V2500-A1 SERIES PROPULSION SYSTEMS SERVICE BULLETIN

This document transmits Revision 2 to Service Bulletin EV2500-72-0340

Reason for change
To add concurrency
statement, add note to
Accomplishment Instructions
and revise Family tree Fig 4

MODIFICATION SERVICE BULLETIN - ENGINE - HP TURBINE ROTOR AND STATOR ASSEMBLY -
PROVIDE A NEW SINGLE FULLY CERAMIC COATED VANE AND A NEW STAGE 1 HIGH PRESSURE
TURBINE COOLING DUCT ASSEMBLY

Modification of the Stage 1 High Pressure Turbine Cooling Duct Assembly
Figure 3 (Sheet 2)

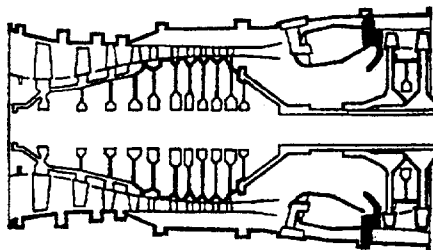
| (a) Weld to build-up the surface as indicated in the referenced figure | Use the manual gas tungsten arc process given in Reference (4), Chapter/Section 70-31-13, Fusion Welding.

Use AMS5832 filler material.
Refer to Figure 3 (Sheet 2) for the weld build-up area |

Location of the Stage 1 High Pressure Turbine Cooling Duct Assembly
Figure 1

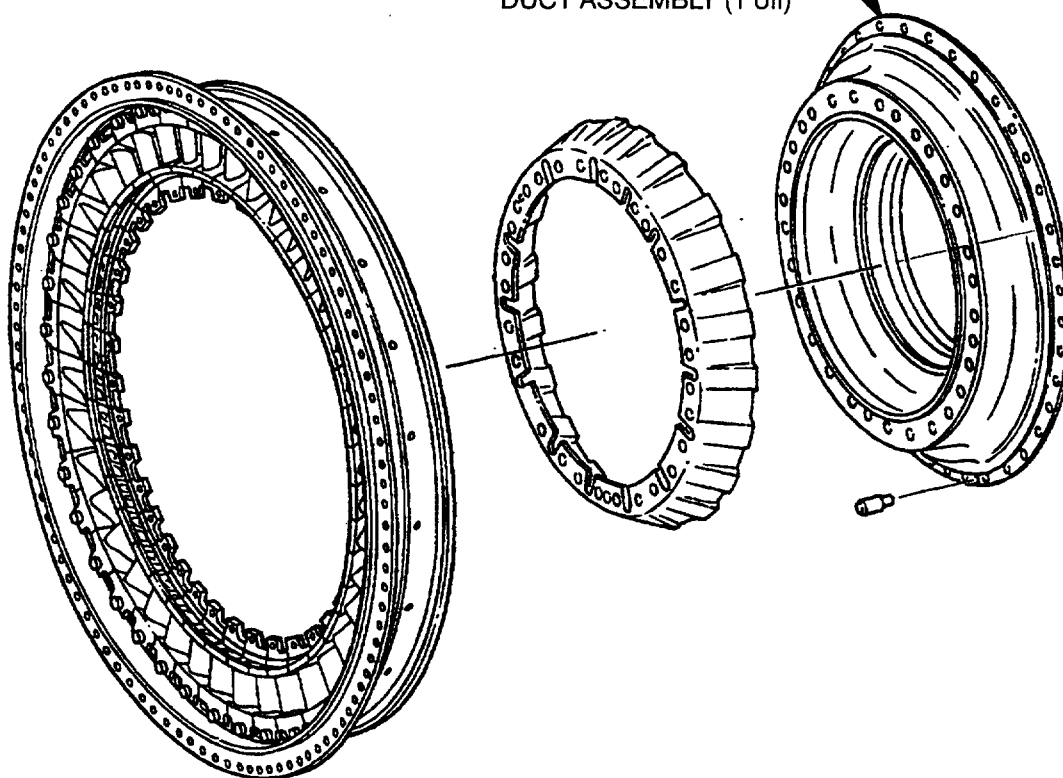
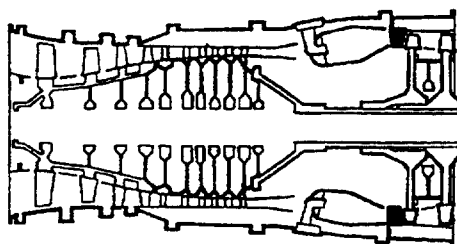
- (1) Install the 2A5591 Stage 1 High Pressure Turbine Vane Assembly (40 off) when you assemble the Stage 1 Turbine Nozzle Assembly by the procedure specified in Reference (3) Engine Manual, Chapter/Section 72-44-00, Assembly. See Figure 2.
- (2) Install either the 2A3329-01 or the 2A1997-001 Stage 1 High Pressure Turbine Cooling Duct Assembly (1 off) when you assemble the Stage 1 Turbine Nozzle Assembly by the procedure specified in Reference (3) Engine Manual, Chapter/Section 72-44-00, Assembly. See Figure 1.

INSTALL THE 2A3329-01
OR THE 2A1997-001
STAGE 1 HPT COOLING
DUCT ASSEMBLY (1 off)

Modification of the Stage 1 High Pressure Turbine Cooling Duct Assembly
Figure 3 (Sheet 1)

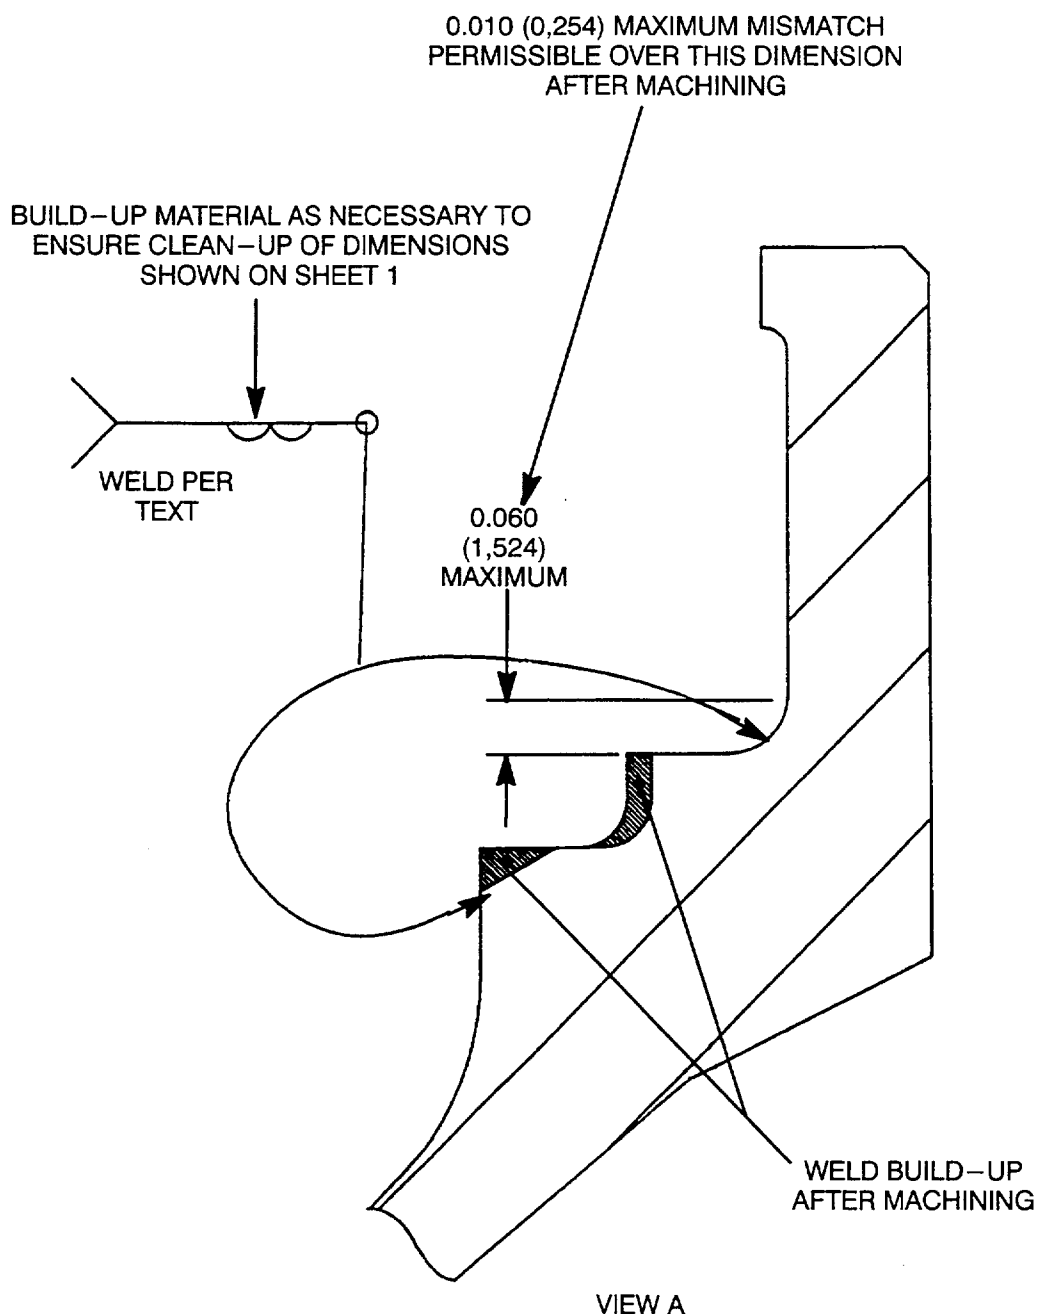
- (1) Do a modification of the 2A1997-01 Stage 1 HPT Cooling Duct Assembly (1 off). See Reference (1), Chapter/Section 72-44-50, Fig./Item No.01-010. See Figures 1 and 3.

| (b) Machine the build-up as shown in the referenced figures | Refer to Figure 3 (Sheet 1).

| (f) Mark the new part number adjacent to the existing part number. Use the vibration peen method | Use the procedure specified in Reference (4), Chapter/Section 70-09-00, Marking of Parts. See Figure 3 (Sheet 1) |
